Project Name: Black Hill Regional Park – SEED Structure

Project Manager/Contact: Judie Lai Agency: Park Development Division

Archaeological Review Attachment: LOD of Black Hill Regional Park SEED Structure Showing STPs and Recommended Area of Avoidance

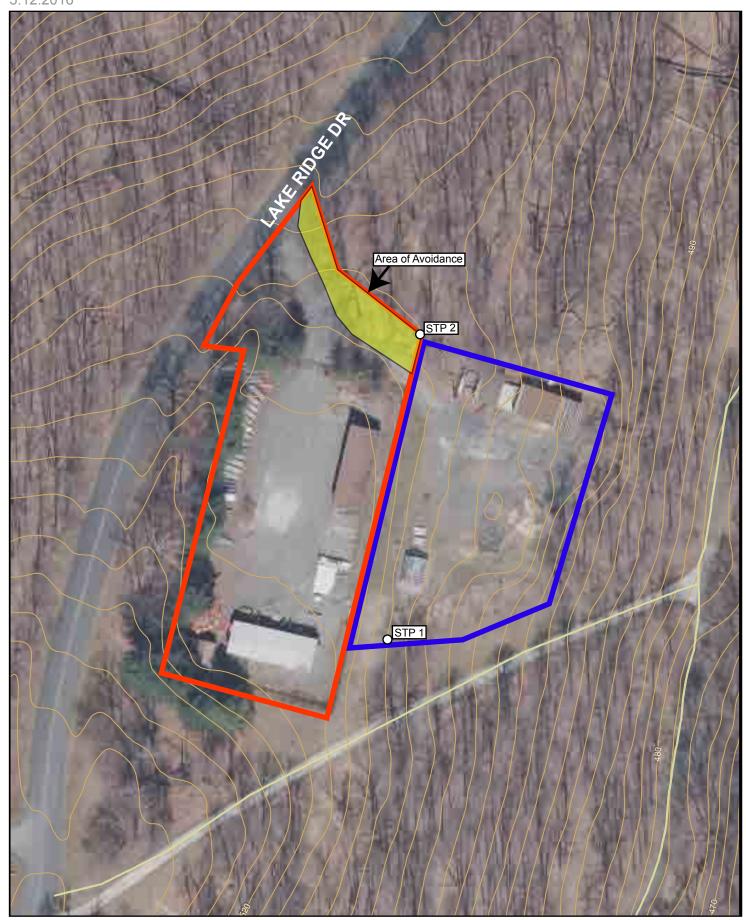
UPDATE 2/8/18: Kelly Arford-Horne completed a field visit to the proposed LOD on 2/6/18 and 2/8/18 to confirm previous disturbance. Two Shovel Test Pits (STPs) were excavated during the site visits, one within the Phase 1 LOD and one within the Phase 2 LOD. The STP within the Phase 2 LOD confirmed the presence of previous disturbance to a depth of at least 2 feet below ground surface. The STP within the Phase 1 LOD revealed the presence of undisturbed soils and was positive for prehistoric resources. STP 2 was excavated approximately 25 feet north of the paved driveway.

6. Recommendations: It is recommended that no ground-disturbing activity, including the movement or staging of heavy equipment, occur north of the paved drive (see attachment). Should ground-disturbing activities in that area prove necessary, additional testing to assess the significance of the known archaeological resources may be required. No impact to intact archaeological resources is likely within the Phase 2 LOD. Should the Phase 1 or 2 LOD change from the one described in this review, additional review and/or testing may be necessary.
